Rezoning Transportation Analysis

Petition Number: 2023-012

General Location Identifier: 14313155, 14314106, and 14327211

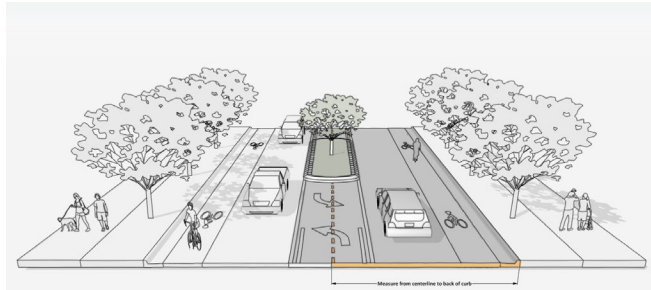
- a. ~~**Speer Boulevard (Shopton Rd Extension):** Location of curb and gutter to be installed 18.5 feet from roadway centerline to the back of curb to accommodate the Charlotte Streets Map with a roadway typical section of a 2-avenue with bike lanes, 8-foot sidewalk and 8-foot planting strip.~~

- b. ~~**Yorkmont Road:** Location of curb and gutter to be installed 24 feet from roadway centerline to the back of curb to accommodate the Charlotte Streets Map with a roadway typical section of a 2+ avenue with bike lanes, 8-foot sidewalk and 8-foot planting strip.~~

~~NOTE: Additional distance from center line to back of curb may be required in locations where a median is present or around intersections and interchanges.~~

~~Label and dimension the curb and gutter from the centerline for each road on the site plan.~~

Outstanding Comment from 6.21.23: ~~Label and dimension the curb and gutter from the centerline for each road on the site plan.~~

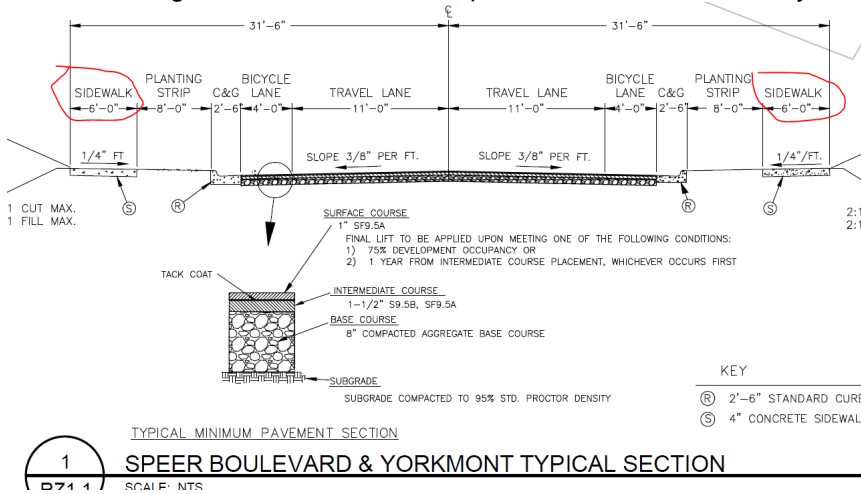
- ~~3. Revise site plan and conditional note(s) to commit to dedicate a minimum of 35 feet of right-of-way from the road centerline on Yorkmont Road and Speer Boulevard. The site plan shall label and dimension the right-of-way from the road centerline.~~

Clarifying comment 6.21.2023: Add conditional note to dedicate a minimum 35 feet of ROW from the roadway centerline of Yorkmont Road and Speer Boulevard. Additionally label and dimension.

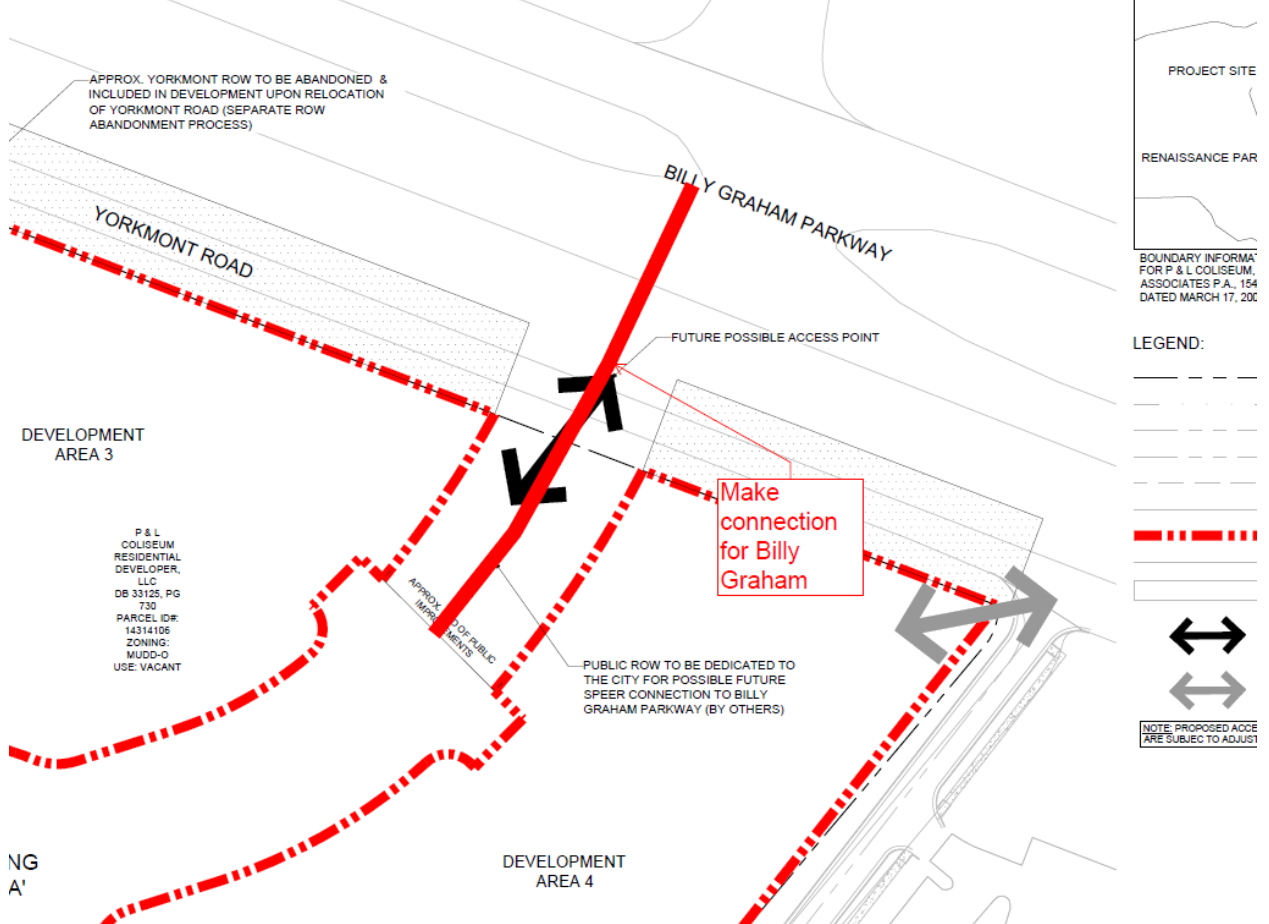
5. ~~Revise site plan and conditional note(s) to commit to construct bicycle facilities by locating the curb and gutter 18.5' on Speer Boulevard and 24' on Yorkmont Road from the center line/installing a bike lane to meet the Council adopted Charlotte BIKES Policy.~~

Clarifying comment 6.21.2023: Add conditional note to construct bicycle facilities on Speer Boulevard and Yorkmont Road.
